Errata Sheet

Product Family:	DL205	Date:	October 2018
Manual Number	D2-HP-M		
Revision and Date	1st Edition, Rev. A; May, 1998

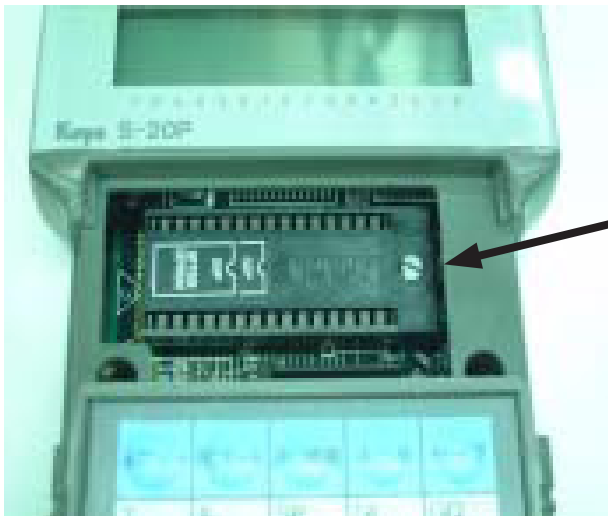
In late 2004, a design change occurred that changed how the EEPROM locks into place. The drawings and text on pages 1-6, 5-4 and 5-5 show the old design, whereby the EEPROM was held into place by a small lever. To replace the EEPROM, raise the lever to loosen the EEPROM. Once the replacement EEPROM is inserted in place, press the lever down to secure it.

On re-designed models, the lever arrangement was replaced by a locking screw, as shown in the photo below. Turn the screw clockwise to loosen and counterclockwise to tighten the EEPROM.

Locking screw secures EEPROM in place. Locking screw replaces lever on models manufactured after October 2004.
